APPLICATION NAME: BOWDENS SILVER MINE AMENDMENT  
APPLICATION NUMBER: SSD5765  
**VISUAL IMPACTS**

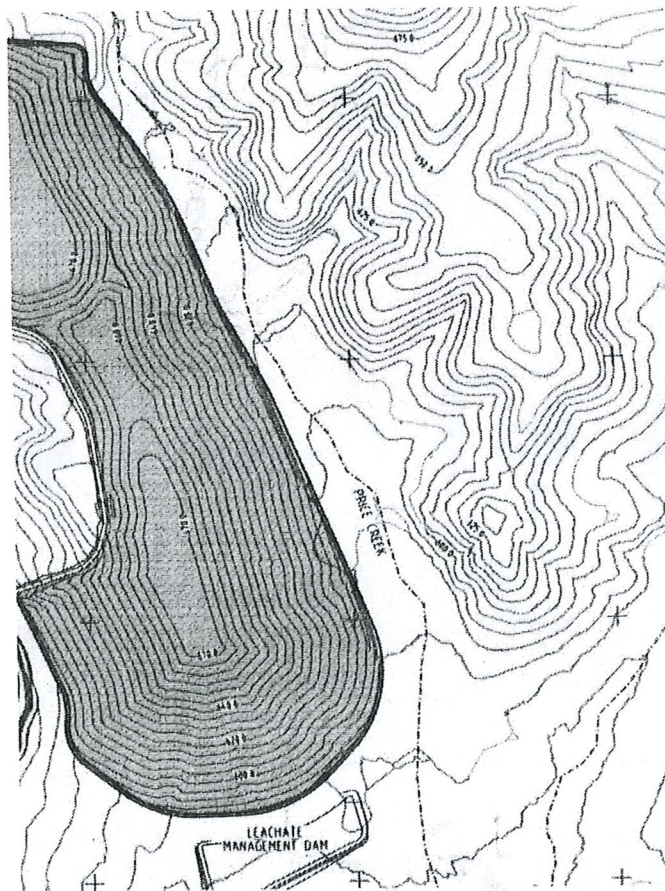
As I asserted a 100 metre high sand castle shaped pile of rocks is a negative outcome and should not be allowed. Is the reader of the proposal documents looking at drawings meant to conclude any different. Simply described the WRE is:

It has slab or planar sides without any natural contour design (nothing like the hills behind it)

The slab sides are at a constant angle of about 25 degrees

The slab sides meet at a ridge (narrow with enough room for single vehicle track)

The ridge is near enough to horizontal (dead straight like a cottage roof or a railway siding grain shed.)...totally unnatural.

This is an appalling feature to foist onto our visual experience but Bowdens propose to leave it like that for ever. Look at it graphically this is a Bowdens map of the WRE.

The shaded mass is the WRE. All but for a tiny wiggle the contours are straight. They are also equally spaced...meaning constant slope. To the right (east) of Price Creek is natural landform. Chalk and Cheese. And furthermore those tiny wiggles are at such a scale invisible; they could simply appear as rough dozer work. It is time for some honesty about the proposal.

"....WRE would achieve a landform resembling a north south orientated ridge with local variation to remove straight sections..." (page 395 Report 429/33)

Does Bowdens think I am both blind and gullible? And to show how visible this will be to Lue Road reference should be made to Figure 5.14 Visual Impact Assessment. It shows clear line of sight to the rock pile.
